CITY OF ISSAQUAH
DEVELOPMENT SERVICES
DEPARTMENT DEVELOPMENT
COMMISSION

STAFF REPORT

FILE NO.: Community Conference: COM15-00001

PROJECT: Fieldstone Memory Care

BUILDING DETAILS / PHOTOS

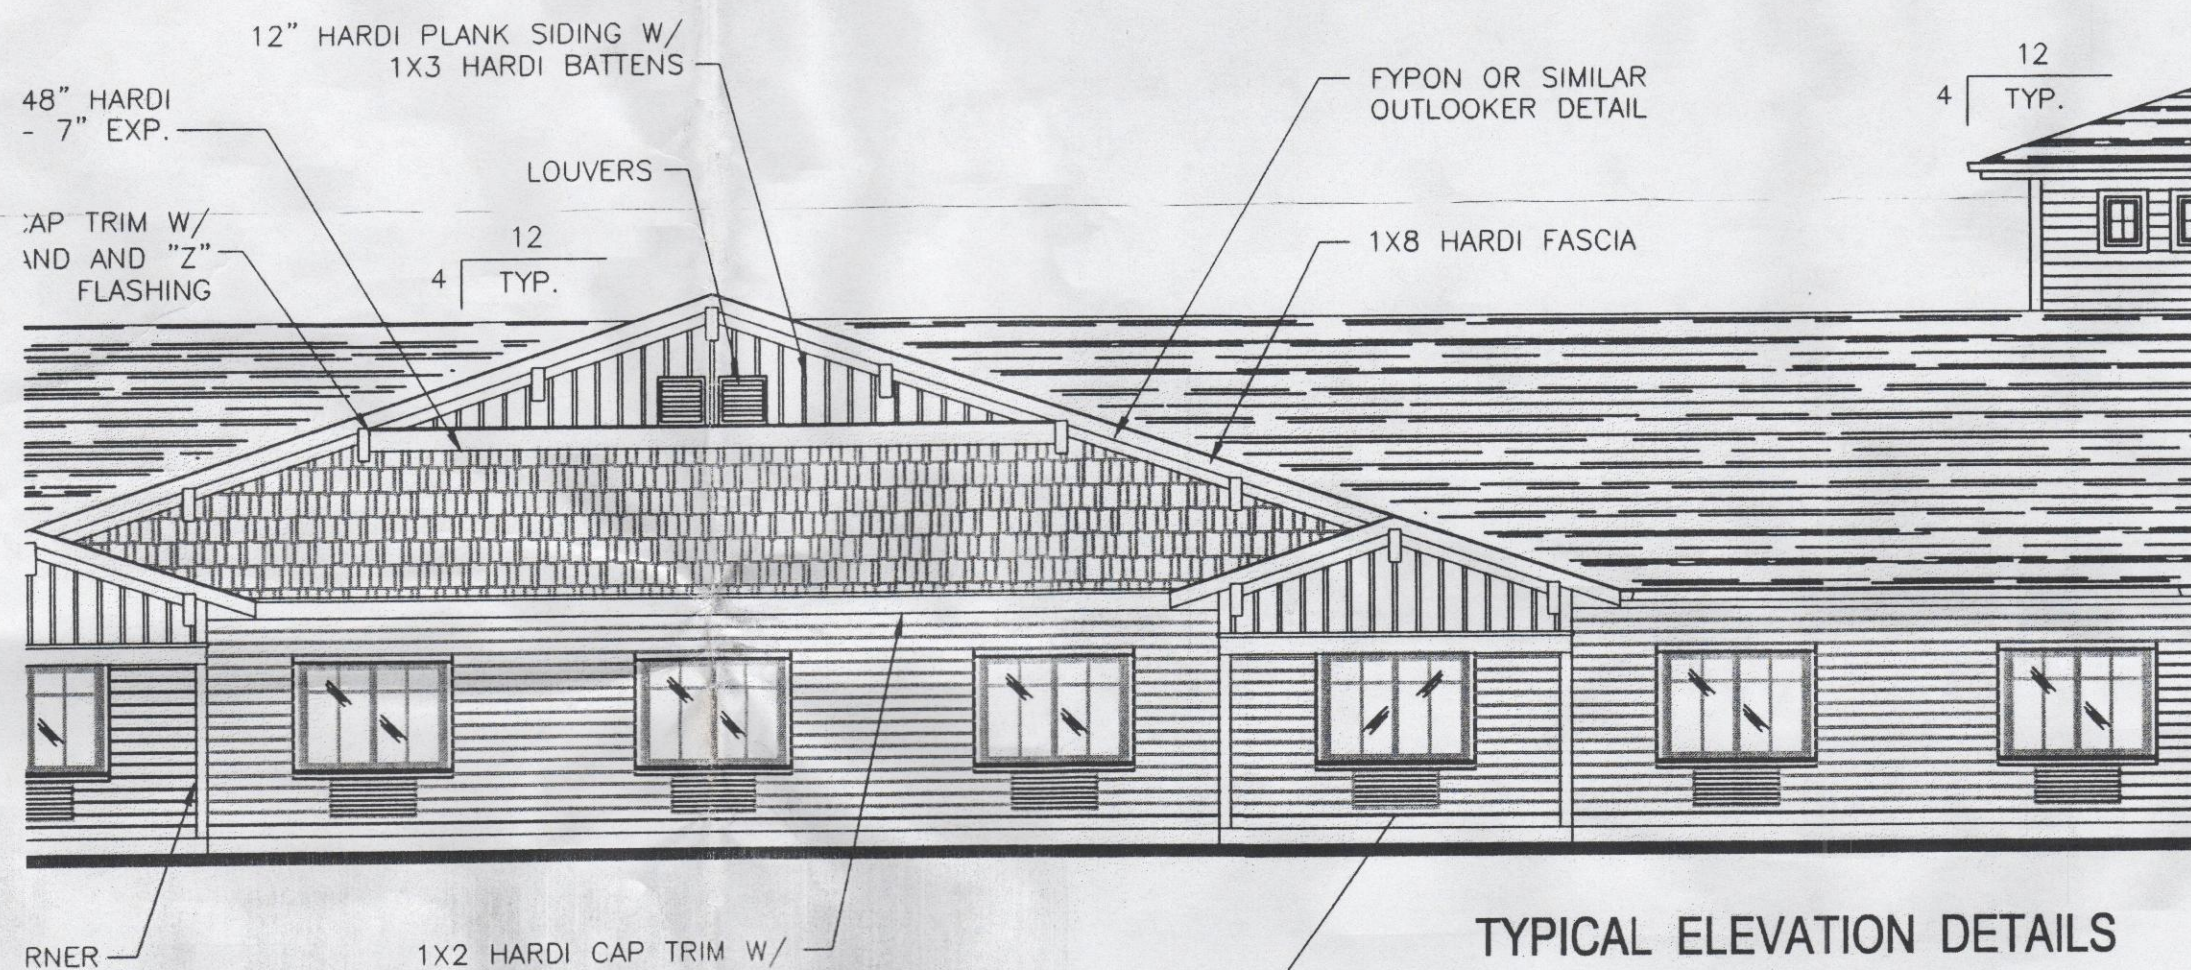
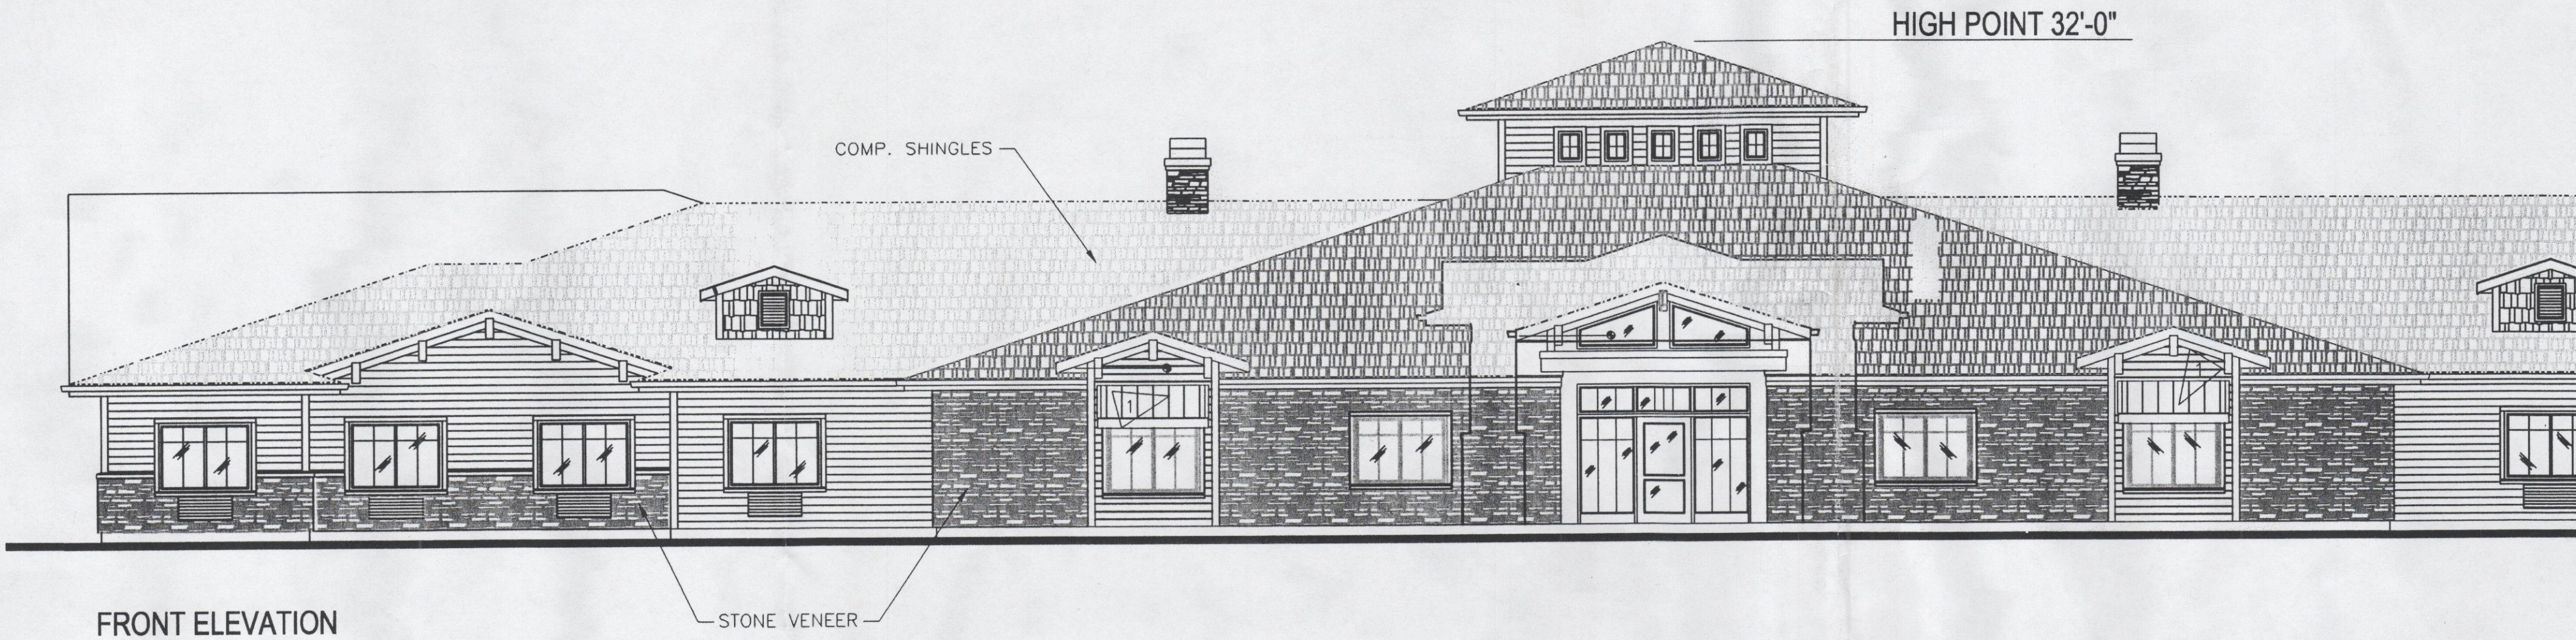
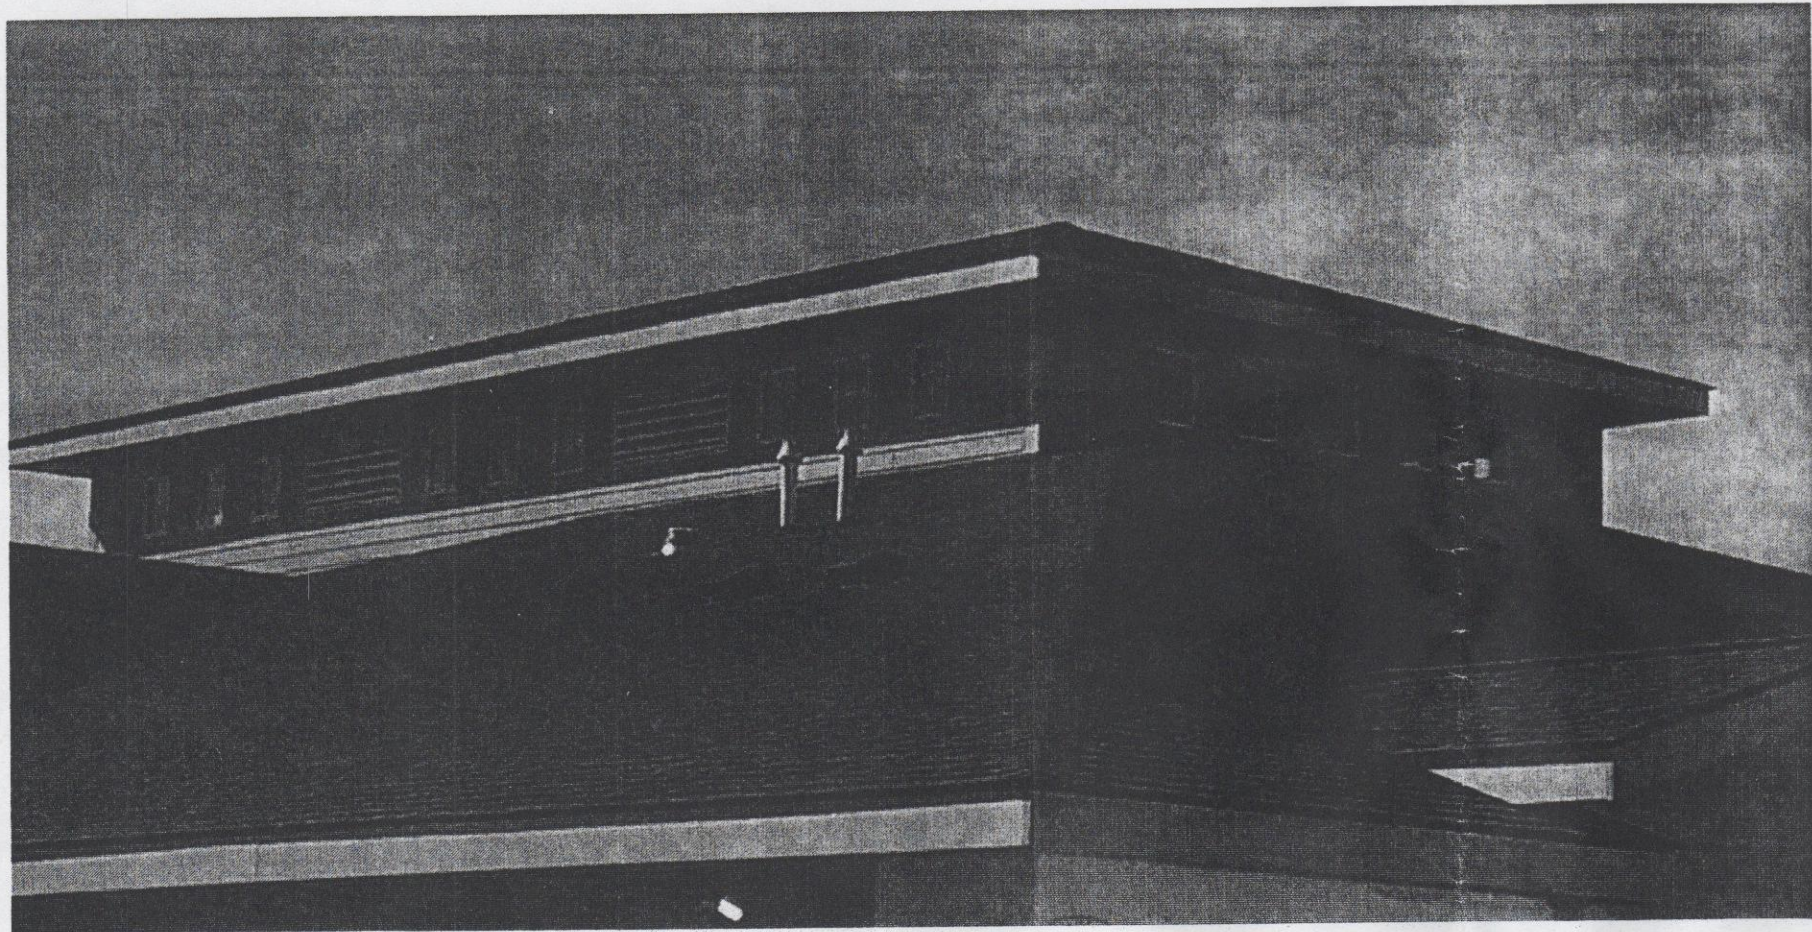
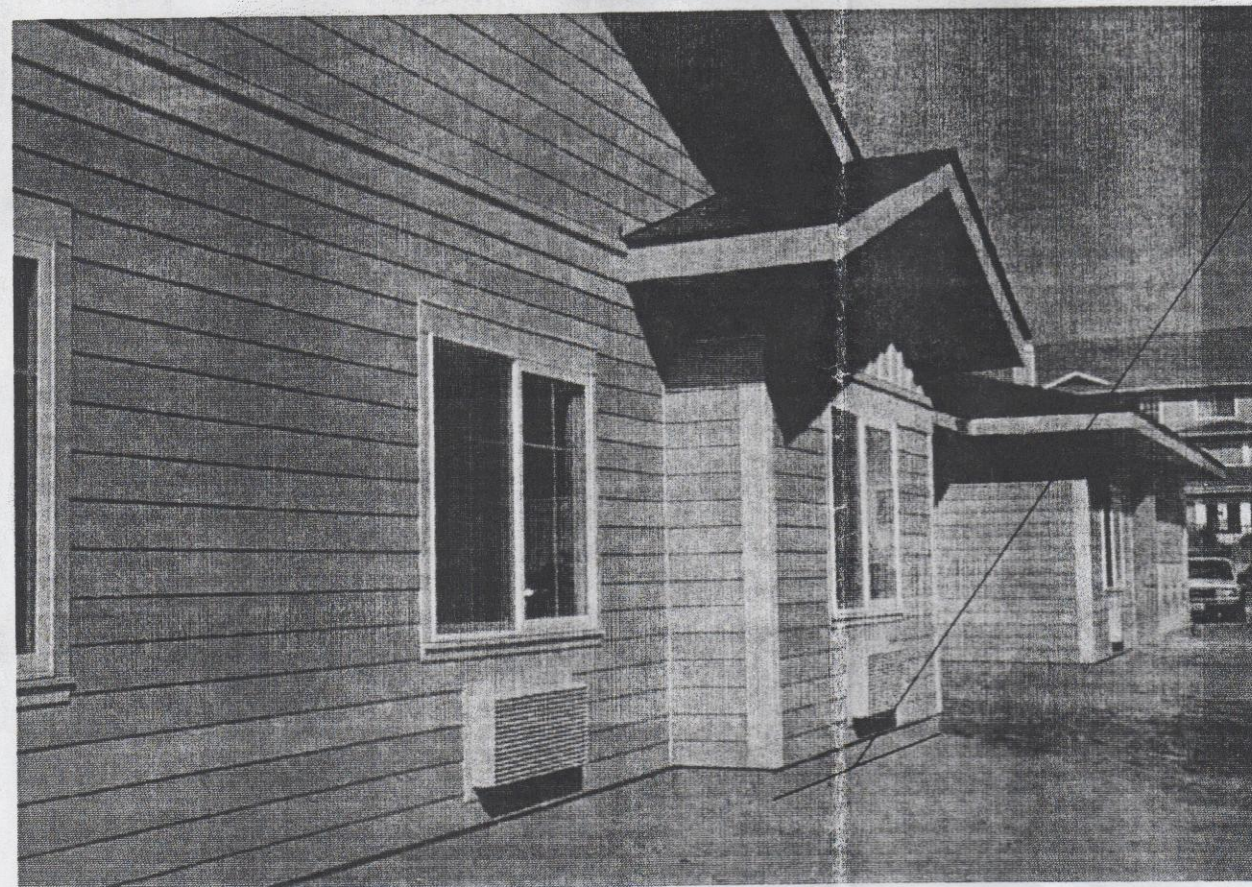
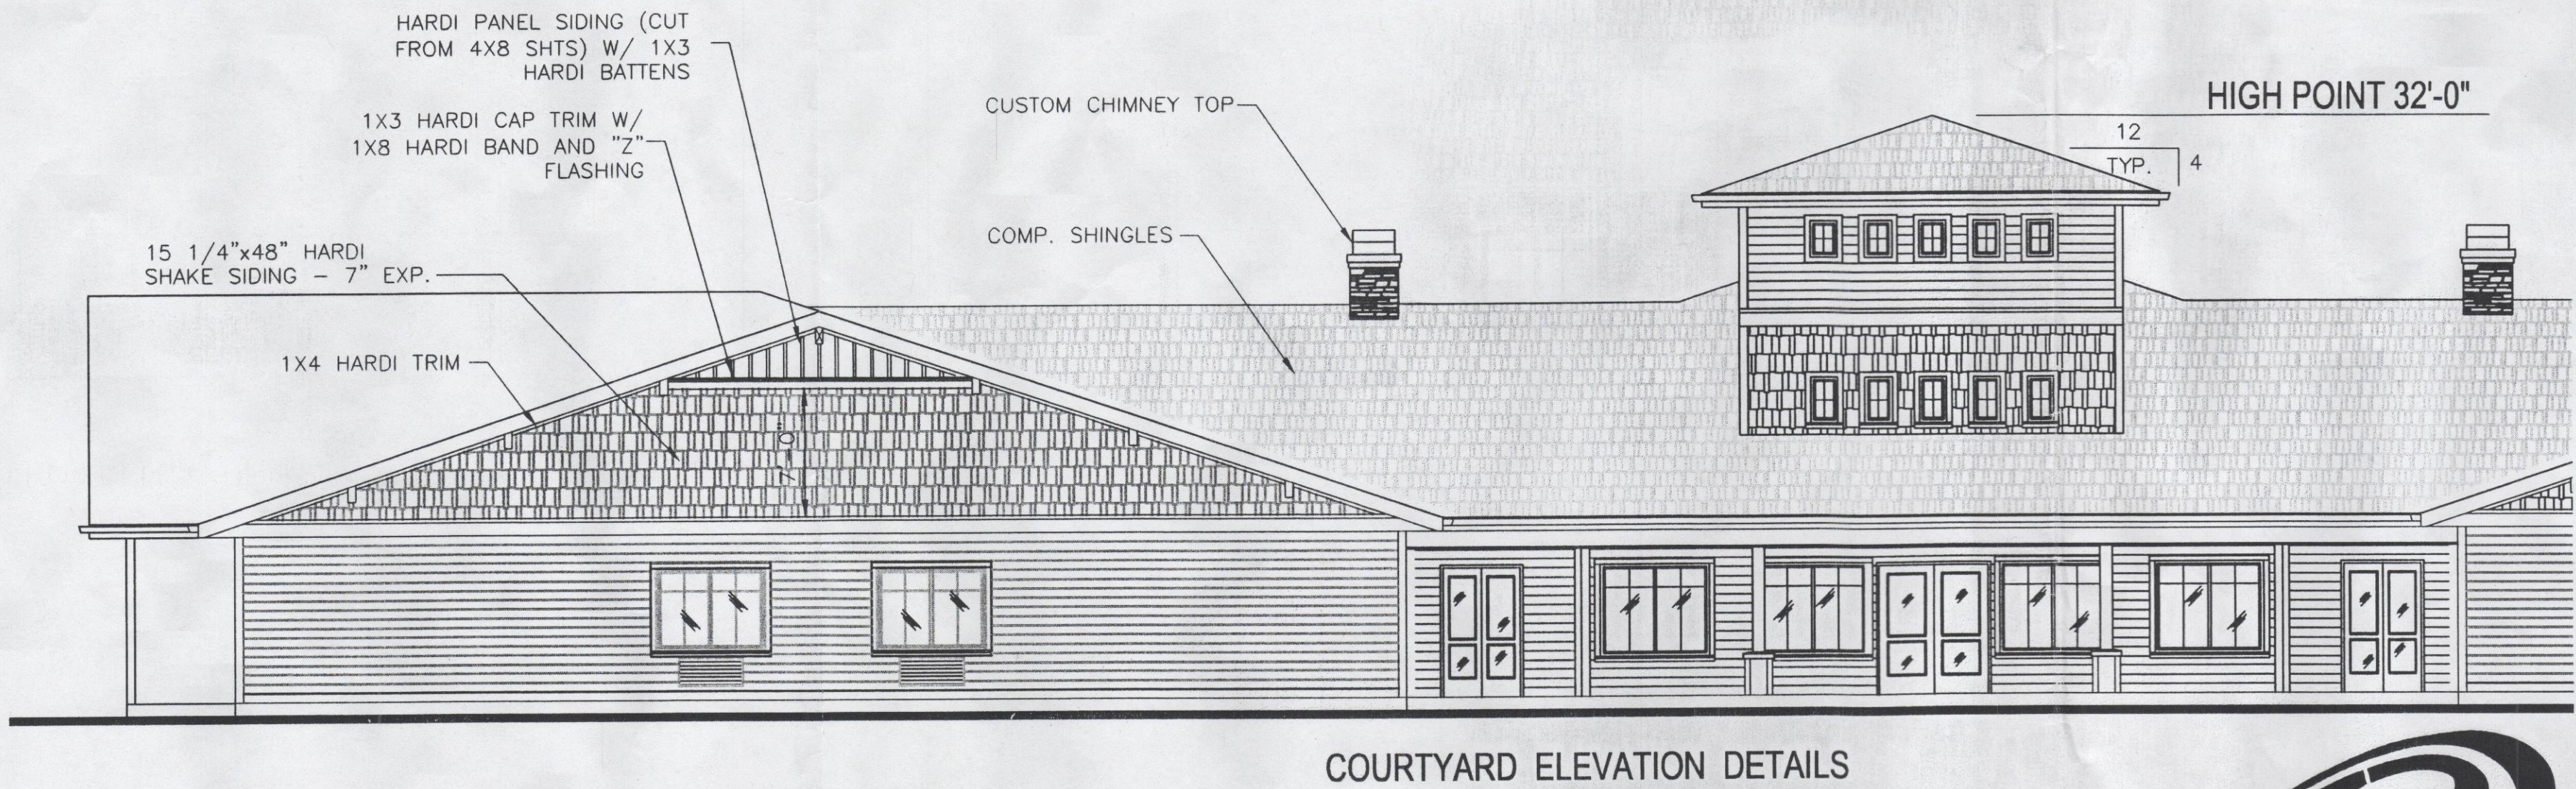
The facility is designed as a one story building and is fairly modulated. Some further modulation may be advisable on the western elevation facing Issaquah-Fall City Rd. as the wall is fairly plain. Landscaping adjacent to the building edge may also be used to add texture to the western facade.
